## **Suffolk County Council**

**Response to the Targeted Consultation 2025**

**Norwich to Tilbury (EN020027)**

Targeted Consultation

**SUFFOLK LOCATION REFERENCE 1  
FOR TARGETED CONSULTATION 2025  
COMPARED WITH STATUTORY CONSULTATION  
2024**

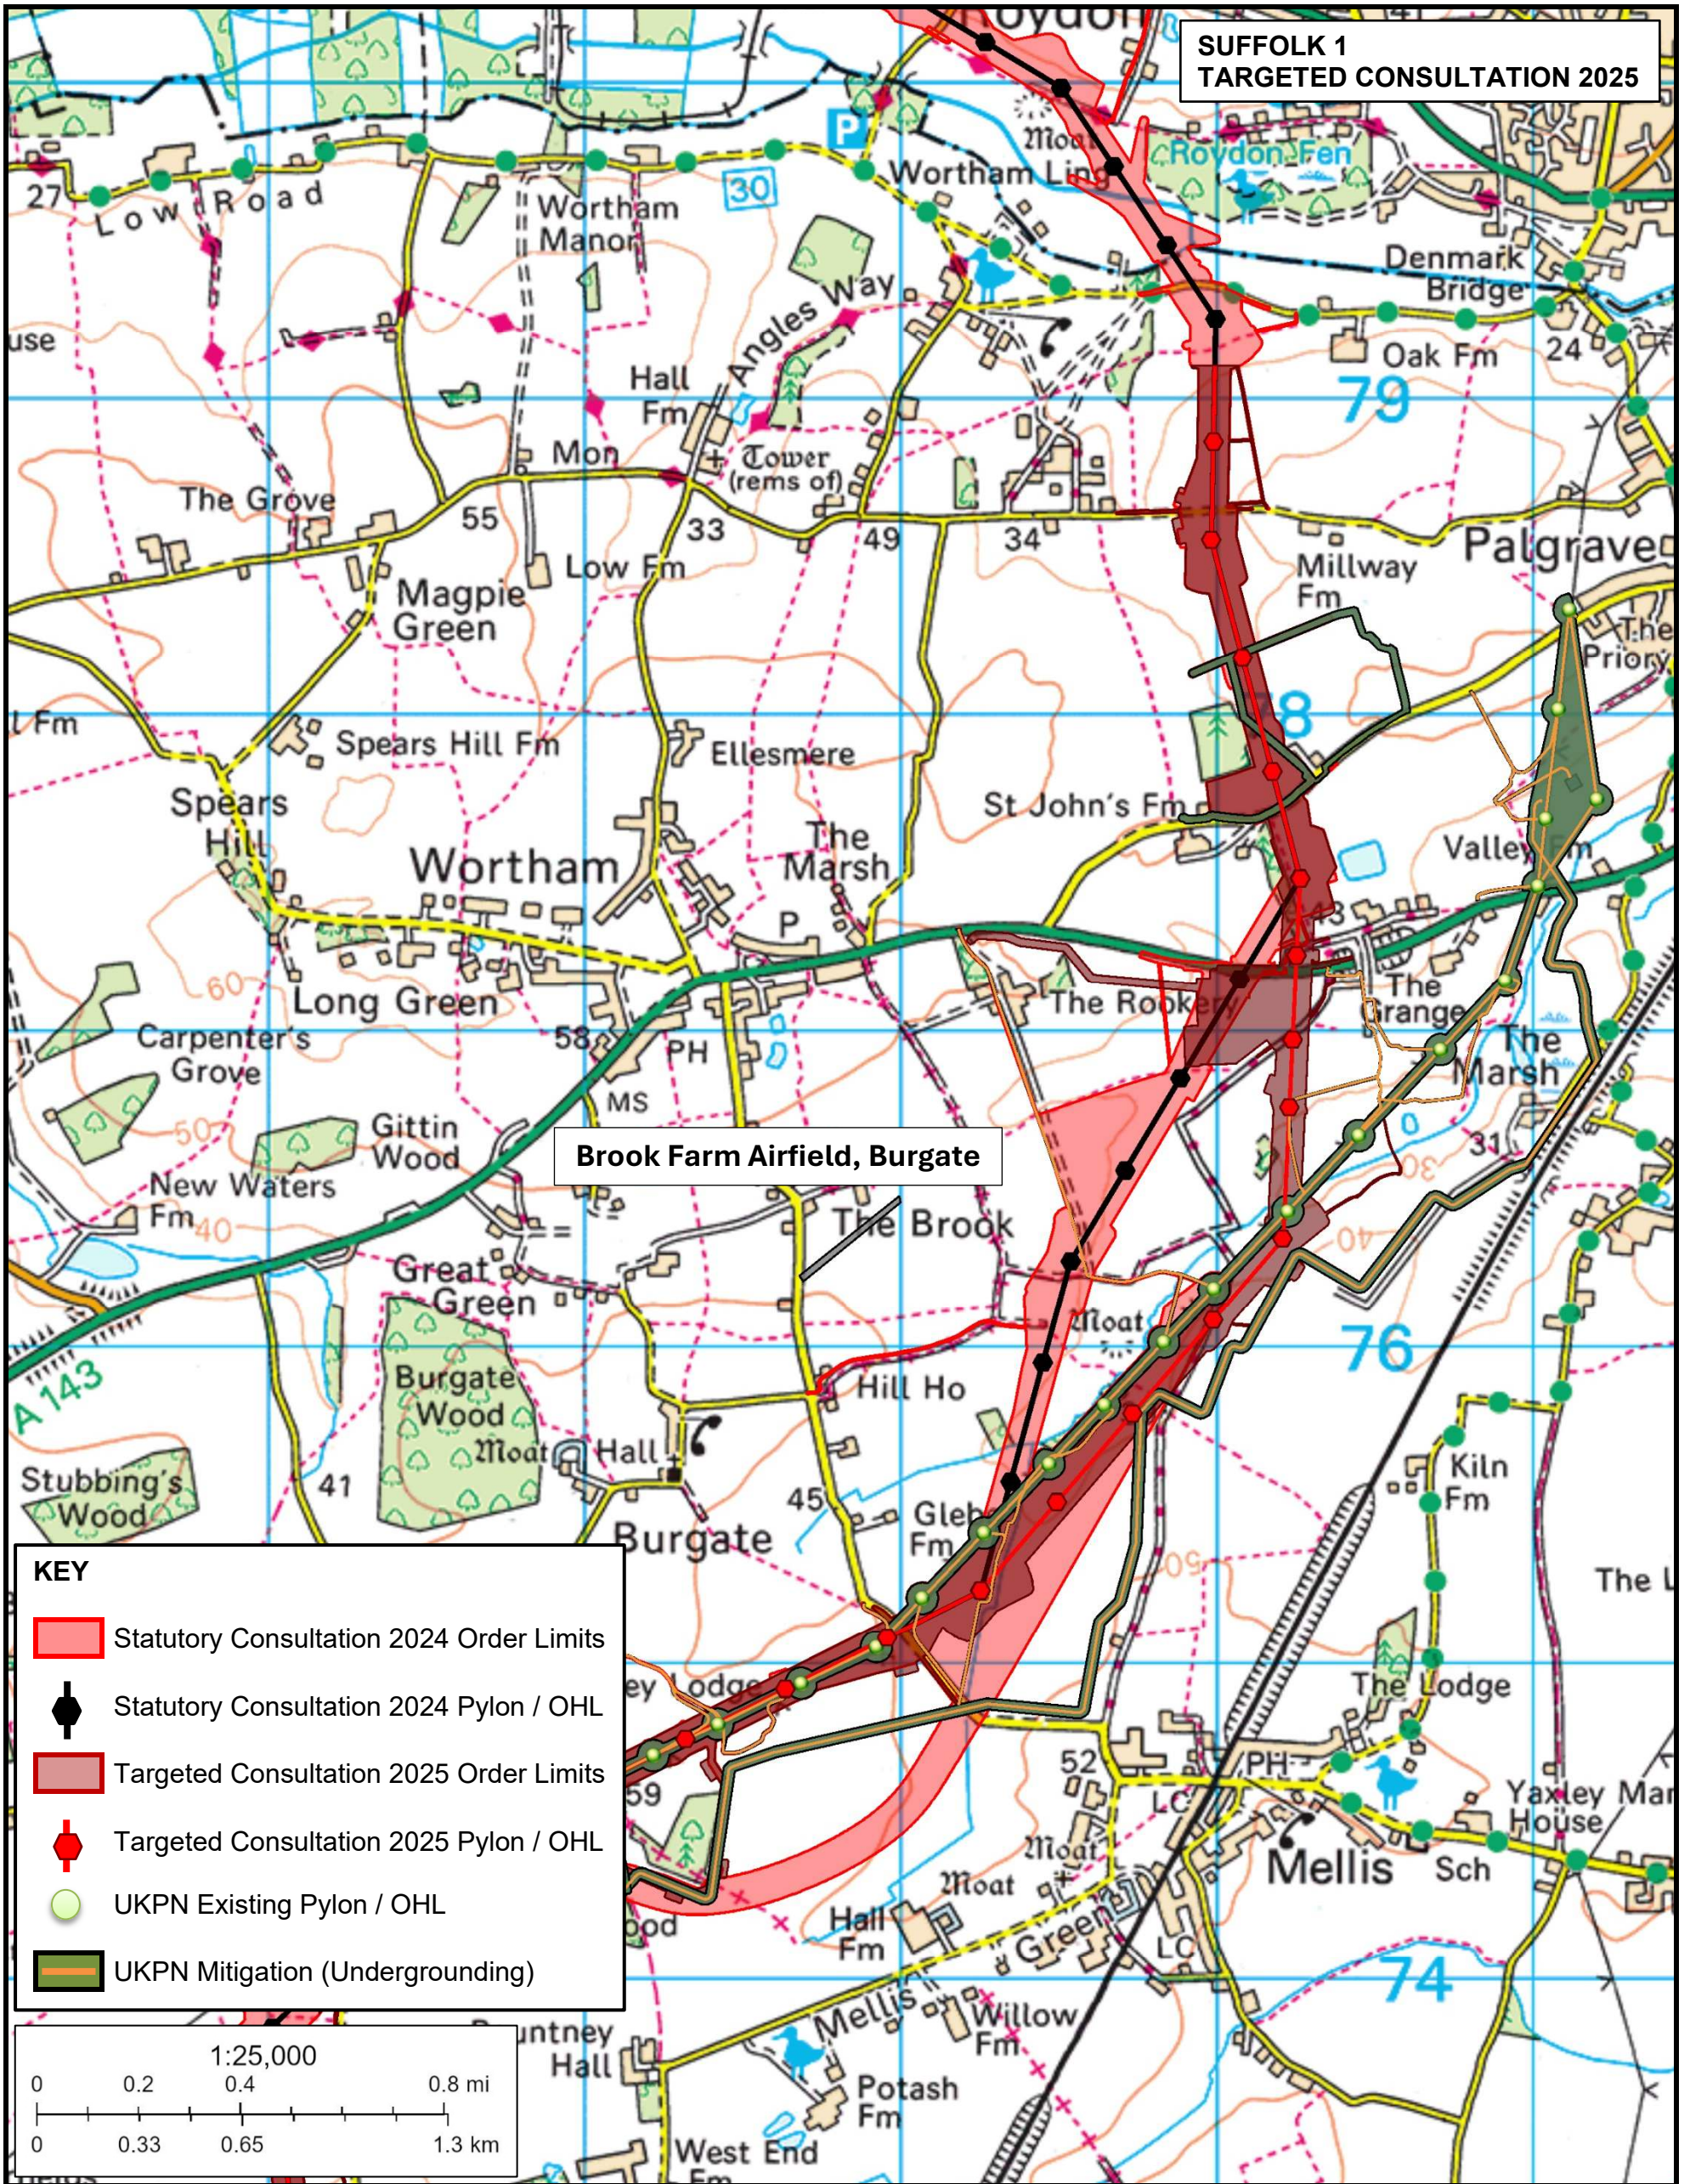
- 2.3. In brief, SCC understands that the proposal at this location is to reposition a line of pylons between Palgrave and Mellis to the south-east of the proposals at statutory consultation, between pylons RG94 and RG102 (previously at statutory consultation RG095 to RG102).

- 2.4. SCC welcomes, in principle, the additional undergrounding of the 132kV powerline, and the closer alignment of the proposed 400kV line with the route alignment of the former 132kV line, as this would reduce over-sailing of the park at St John’s House, make residential properties around The Grange and Spring Cottages less hemmed in by powerlines west and east, and would reduce adverse effects on a Brook Farm airstrip.

- 2.5. Recognising at least part of the alignment within the proposed change will be closer to residential properties, SCC suggests that there could be reasonably be an increased risk of Public Health impacts to the localised community including examples of stress and anxiety of Electromagnetic Field (EMF) concerns, increased noise.

- 2.6. The proposed changes are likely to cause greater ecological impact than the previous scheme design, particularly due to the impacts at Thrandeston Marsh County Wildlife Site (CWS). It is noted that the CWS is not only designated for its wet grassland but a range of associated habitats and its connections via hedgerows to the wider landscape. All features of interest at the CWS should be assessed with regard to impacts upon them and mitigated appropriately.

- 2.7. Because of the high archaeological potential of this area, Suffolk County Council's Archaeological Service (SCCAS) would recommend pre-determination archaeological evaluation comprising geophysical survey and trenched archaeological evaluation, of both the compounds and undergrounding of the 132kV in this area as this has the potential to impact delivery of the overall scheme.
- 2.8. There are no changes to PROW.

- 4.7. This section of the route is within an area of very high archaeological potential as indicated by information held in the Historic Environment Record (HER). The proposed overhead route Construction laydown area, Overhead compound (RG main) and undergrounding of the 132kV line is in close proximity to the site of the Chapel of St John, a medieval chapel mentioned in The Domesday Book (PAL 003), and in close proximity to artefact scatters indicative of a Roman and Saxon inhumation and cremation cemetery (WTM 050).

- 4.8. Further archaeology recorded on the HER within close proximity to the scheme:
- a. BUR 010: post medieval tile kiln
  - b. BUR 012: Medieval moat
  - c. BUR 013: Cropmark of a ringditch, probable prehistoric funerary monument

- d. SUF 009: Projected line of a possible Roman road it must be noted that Pylon RG101 on top of the (SUF 009)
  - e. TDE 008: substantial spread of burnt flint, indicative of a Bronze Age burnt mound

- f. PAL 022: Saxon Gold disc pendant
- 4.9. Trandeston Marsh visible on the 1783 Hodskinsons Map of Suffolk, which has the potential to contain important palaeoenvironmental and other organic archaeological remains.

- 4.10. Because of the high archaeological potential of this area SCCAS would recommend pre-determination archaeological evaluation, comprising geophysical survey and trenched archaeological evaluation, of both the compounds and undergrounding of the 132kV in this area as this has the potential to impact delivery of the overall scheme.

- 4.11. There also needs to be appropriate provision for hydrological, geoarchaeological and palaeoenvironmental assessment of the undergrounding of the 132kV line.

*“The proposed change increases the amount of underground cabling. While the majority of the proposed additional underground cabling goes through arable land, the alignment does pass through Thrandeston Marsh Local Wildlife Site designated for its wet grassland habitat. This would require additional mitigation measures to reduce any likely effects. The proposed change crosses additional well-defined field boundaries with mature planting bands (including hedgerows and woodland bands) therefore would have a greater effect on these features (which are not designated features).*

- 5.5. The status of the additional “well-defined field boundaries”, would require detailed assessment with regard to biodiversity value and against the Hedgerow Regulations 1997, where appropriate and mitigated accordingly.
- 5.6. The proposed changes are likely to cause greater ecological impact than the previous scheme design, particularly due to the impacts at Thrandeston Marsh CWS. It is noted that the CWS is not only designated for its wet grassland but a range of associated habitats and its connections via hedgerows to the wider landscape. All features of interest at the CWS should be assessed with regard to impacts upon them and mitigated appropriately.

- 9.5. SCC Landscape welcomes, in principle, the additional undergrounding of the 132kV powerline, and the closer alignment of the proposed 400kV line with the route alignment of the former 132kV line, as this would reduce over-sailing of the park at St John's House, make residential properties around The Grange and Spring Cottages less hemmed in by powerlines west and east, and would reduce adverse effects on a Brook Farm airstrip.

- 9.6. SCC Landscape considers that the undergrounding of the 132kV line should have explored further to PK40 (near Elm Vale Farm), in particular as the Waveney Valley Alternative remains no longer viable.

- 9.7. The additional loss in vegetation, resulting from the new alignment crossing a more intricate landscape with a denser network of treed hedge lines and wooded areas, as well as the relocation of bellmouths, access points and hauls roads is however of concern and would need to be fully assessed and mitigated. The loss of additional veteran tree should be avoided.

- 9.8. Where the proposed undergrounded section of the 132kV line ends at Red Cottages, it would need to be carefully considered where the change from underground to overhead is made. SCC (Landscape) considers that it would be preferable to have overhead lines across the A143 to avoid roadside vegetation loss.

- 9.9. The new location for the temporary construction compound should not result in additional vegetation losses.
- 9.10. SCC Landscape considers that not all the changes in this area have been sufficiently explained, for example the assumed haul road (without hatch) west of the relocated construction compound, and what looks like additional undergrounding around RG92-RG93.

- 11.1. Proposed position of RG95 appears to be in close proximity with a structure. This notwithstanding, the Health and Wellbeing row of the Environmental Topic table has the following wording: *The proposed change would locate the alignment closer to a number of health and wellbeing receptors, including residential properties, but further from others. There would be no change to the type or significance of health and wellbeing effects as a result of the proposed change, when compared to the design and PEIR presented at statutory consultation.* Recognising at least part of the alignment within the proposed change will be closer to residential properties, SCC suggests that there could be reasonably be an increased risk of Public Health impacts to the localised community including examples of stress and anxiety of EMF concerns, increased noise.

**SUFFOLK LOCATION REFERENCE 2  
FOR TARGETED CONSULTATION 2025  
COMPARED WITH STATUTORY CONSULTATION  
2024**

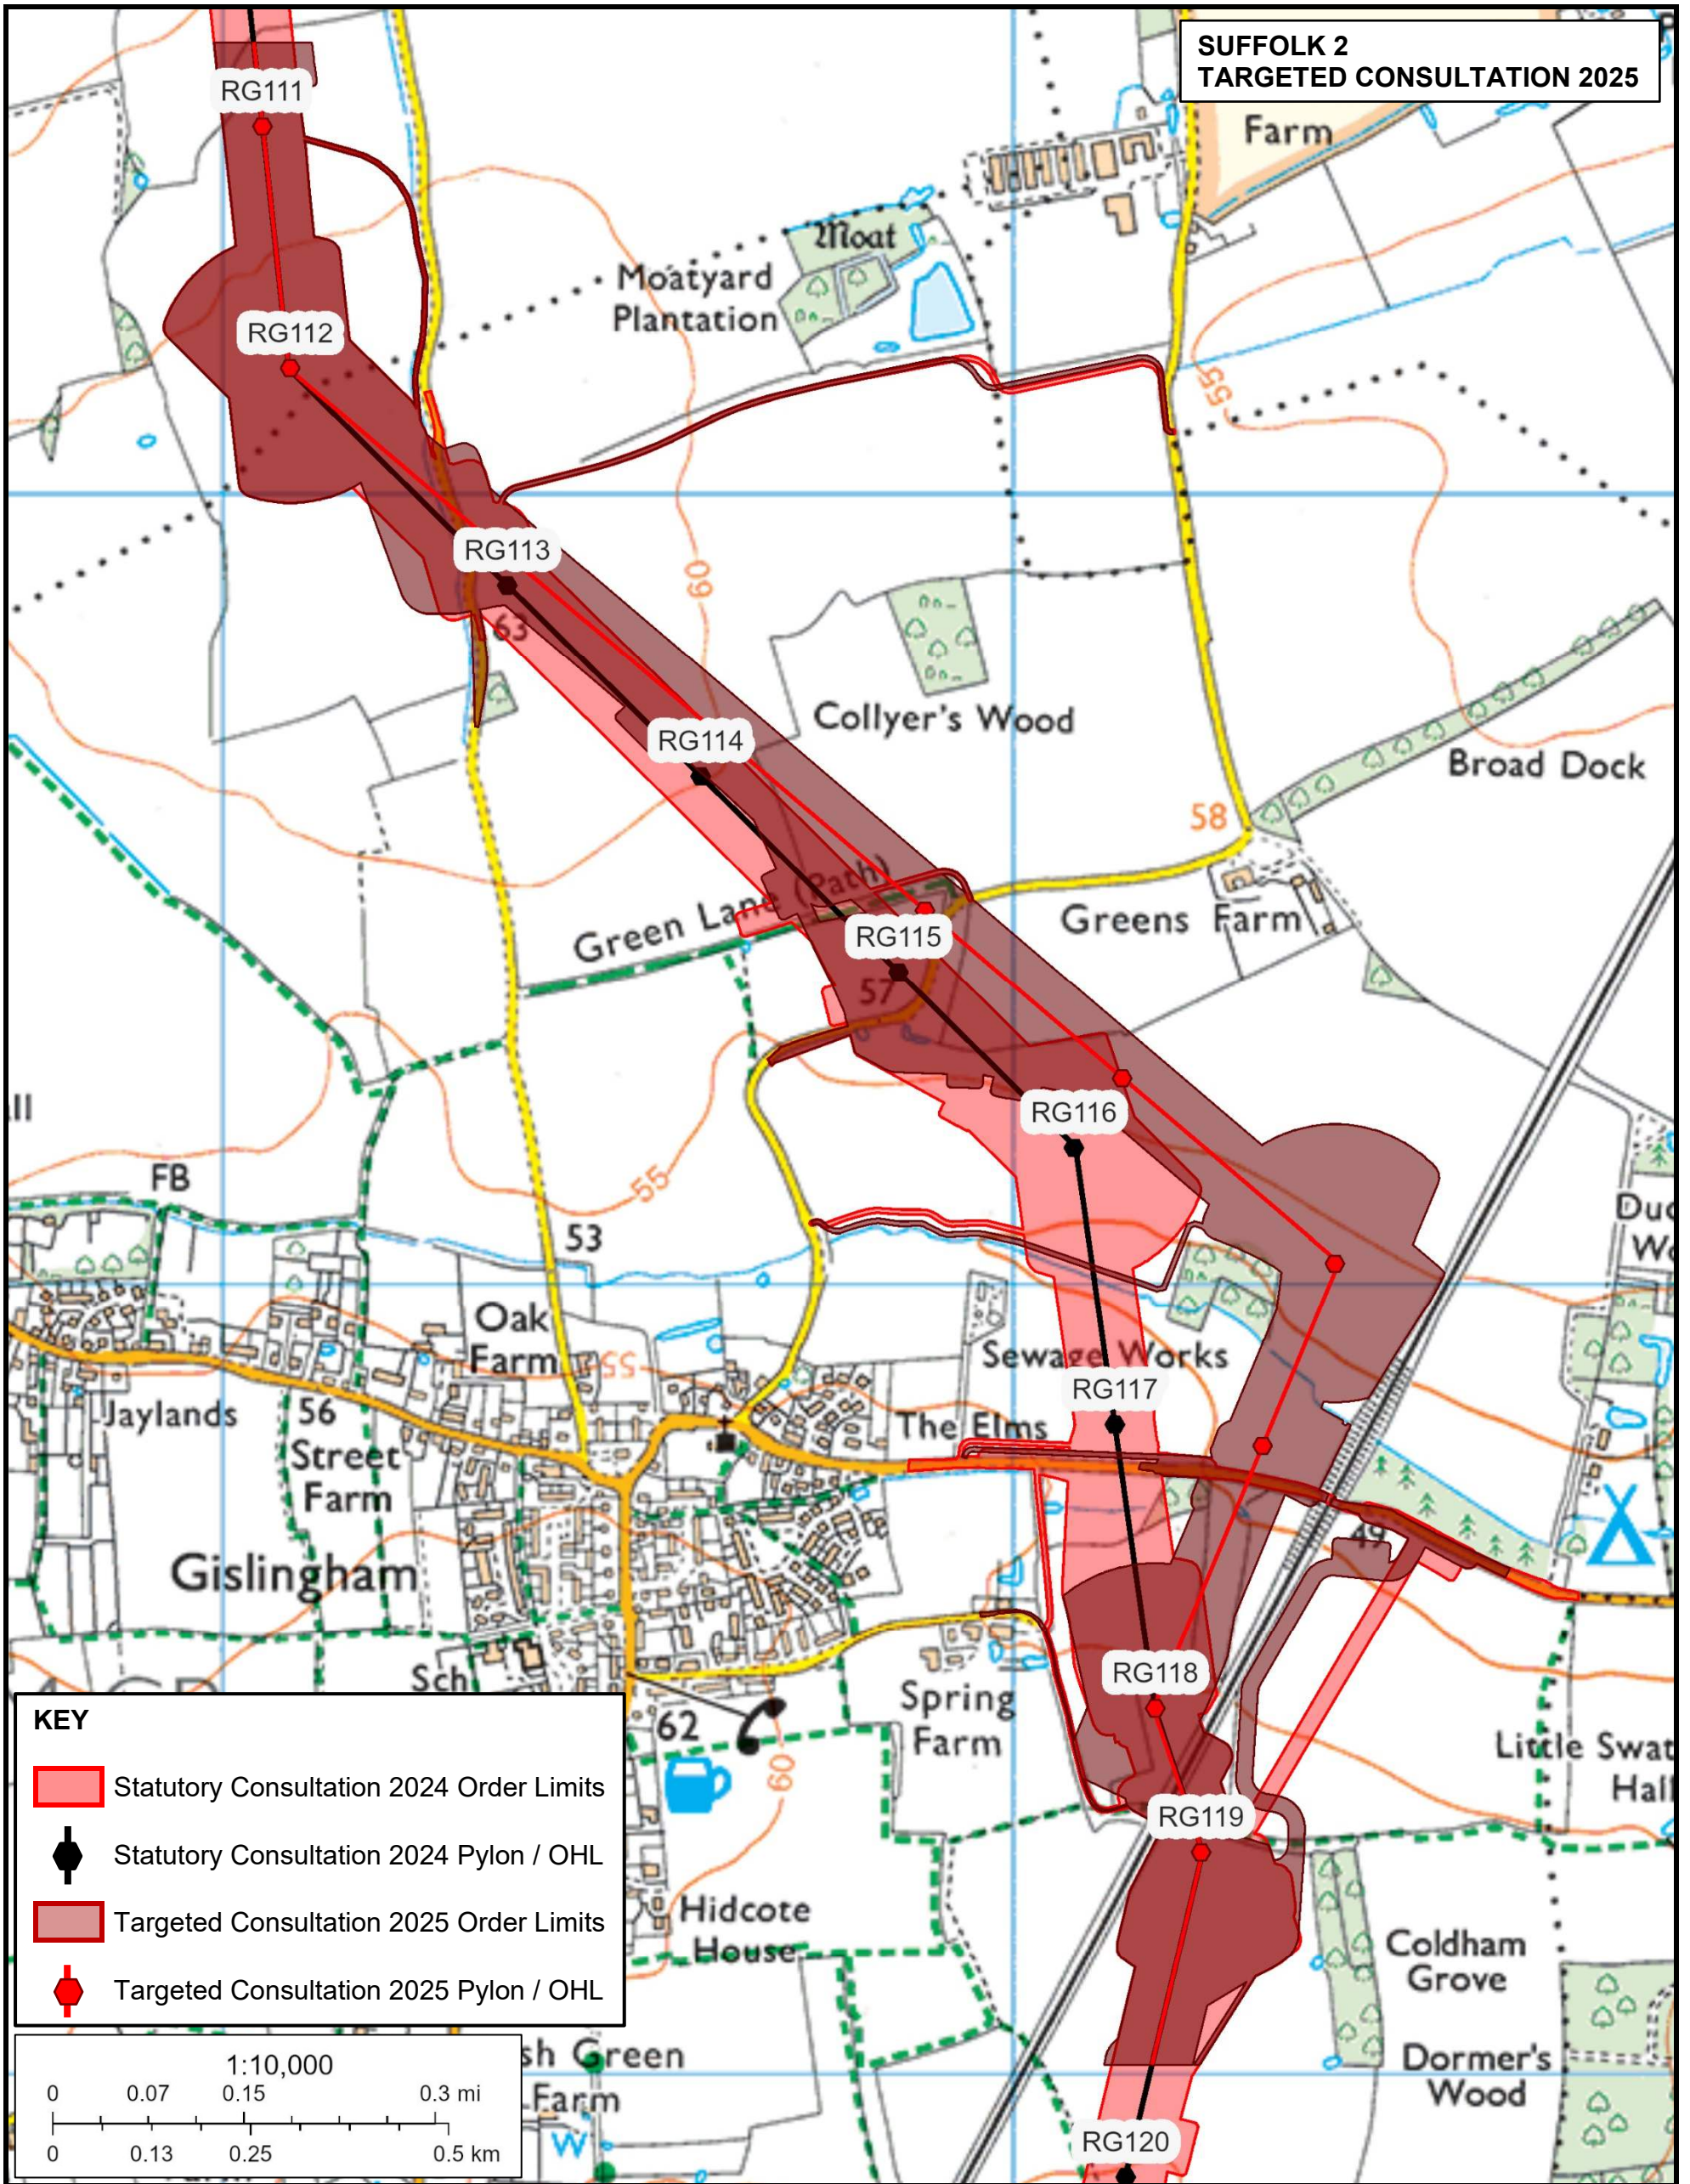
- 2.9. In brief, SCC understands that the proposal at this location is to reposition the overhead line alignment, away from Gislingham and to the west of the railway track, between pylons RG114 and RG119 (previously at statutory consultation RG114 to RG118).
- 2.10. SCC welcomes the proposed changes, in principle, as they would put the 400kV line at a greater distance from some parts of Gislingham.
- 2.11. SCC also welcomes the alteration of line which would reduce potential impacts on veteran trees.
- 2.12. However, the proposed changes have the potential to increase the probability of encountering as yet unknown Early medieval and medieval archaeology.
- 2.13. Pylon RG115 appears to be in close proximity to PROW Bridleway W-267/014/0. The report does not mention/address/mitigate the relocation to potentially impact on the PROW.

- 4.12. Based on currently available information there are no major changes for archaeology based upon the information within the HER.
- 4.13. However, the movement of pylons RG116, RG117 and RG118 places the pylons in closer proximity to archaeological heritage assets recorded in the county HER which are indicative of early medieval and medieval activity. These heritage assets comprise:

- a. GSG 013: Saxon artefact scatter
  - b. GSG 005: the proposed site of Swatshall or Swattisfield Hall, which includes the earthwork remains of an infilled moated enclosure, undated cropmarks, and indications of possible kiln sites

- c. GSG 053: Saxon Brooch, buckle and coin along with a post-medieval ring
- 4.14. The proposed changes have the potential to increase the probability of encountering as yet unknown early medieval and medieval archaeology.

- 4.15. Table 1.2.3 the Historic Environment section should acknowledge the potential to encounter as yet unknown archaeological heritage assets.

- 5.7. SCC Ecology welcome the alteration of line which would reduce potential impacts on veteran trees. Otherwise, the Council concurs with the assertion that there will be no change in effects.

- 8.3. It is noted that the proposed permanent access location will be relocated and that the crossings over Burgate Road and Major Road will also be moved. Further details such as scaled plans would be needed for the authority to

provide a response although the visibility from the crossing and into the compound at Major Lane should be checked to ensure it is acceptable for traffic passing through the rail bridge.

- 9.11. SCC Landscape welcomes the proposed changes, in principle, as they would put the 400kV line at a greater distance from some parts of Gislegham.

- 9.12. It would have been preferable, if the changes could have gone further, as previously requested by SCC, to avoid the vegetation at Green Lane altogether and to avoid crossing Burgate Road twice.

- 9.13. Continued undergrounding of the UKPN line to PKF14 would have reduced the concentration of energy infrastructure at Burgate Road.
- 9.14. It is unclear what the resulting adverse impacts and effects would be following the relocation of the bellmouth on Burgate Road 110m to the south. This could conflict with the nearby wooded area on the eastern side and affect the property adjacent to the west. SCC considers that the loss of any mature roadside trees should be avoided.

- 9.15. It is welcome that the access between Major Lane/Thornham Road and Coldham Lane has been removed from the proposals and relocated 200m east, although the exact location is unclear. SCC reiterates that this should be in a location which is less densely vegetated.

- 9.16. It is further unclear from where the construction compound north of Thornham Road was relocated. It does appear to be located too close to the railway line resulting in the risk of unnecessary loss of vegetation along the railway line, which SCC Landscape would not consider acceptable.
- 9.17. SCC Landscape welcomes the new routing of the haul road east of the railway line, as it lessens the disturbance of agricultural land and makes use of existing tracks through vegetated areas.

- 10.4. No separate PROW Category is listed on the document, as requested in previous responses.
- 10.5. Pylon RG115 appears to be in close proximity to PROW Bridleway W-267/014/0. The report does not mention/address/mitigate the relocation to potentially impact on the PROW.
